Access Compliance Report

Public Rights-of-Way

Intersection ID: 11436	Main Street: E_19TH_ST	Cross Street: N_DAVIDSON_ST	Location: E
ADA ID: 3C22635BF28B	Ramp Type: PerpDiag	Initial Pass/Fail: Fail	Overall Compliance: No
			Severity Score: 13.75

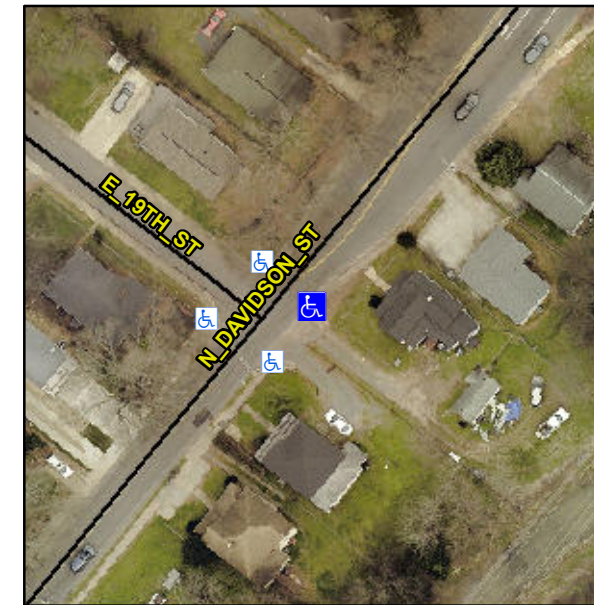
Not Found, R304.2.2

Compliance	Description	Data	Compliance	Description	Data
N/A	Ramp Length (in)	48.0	No	Ramp Slope (%)	11.5
Yes	Ramp Width (in)	48.0	Yes	Ramp XSlope (%)	2.4
N/A	Flare Type LT	N/A	N/A	Flare Type RT	N/A
N/A	Flare Slope LT (%)	N/A	N/A	Flare Slope RT (%)	N/A
N/A	Flare Traversable LT?	N/A	N/A	Flare Traversable RT?	N/A
N/A	Landing Length (in)	N/A	N/A	DWS Provided?	N/A
N/A	Landing Width (in)	N/A	N/A	DWS Contrast?	N/A
N/A	Landing Slope (%)	N/A	N/A	DWS Length (in)	N/A
N/A	Landing X Slope (%)	N/A	N/A	DWS Full Width?	N/A
N/A	Landing Curb? (Y/N)	N/A	N/A	DWS Offset (in)	N/A
N/A	Shared Landing?	N/A			
N/A	Gutter Ponding?	Yes	N/A	Gutter Slope (%)	N/A
N/A	Gutter Lip Ht (in)	N/A	N/A	Gutter X Slope (%)	N/A
N/A	Painted X Walk1?	No	N/A	Painted X Walk2?	No
	X Walk 1 Direction	To NW		X Walk 2 Direction	To SW
N/A	X Walk 1 Width (in)	N/A	N/A	X Walk 2 Width (in)	N/A
	X Walk 1 Slope (%)	3.1		X Walk 2 Slope (%)	2.2
	X Walk 1 X Slope (%)	0.5		X Walk 2 X Slope (%)	0.4

Remove & Replace Curb Ramp With Two New Directional Ramps or Equivalent.
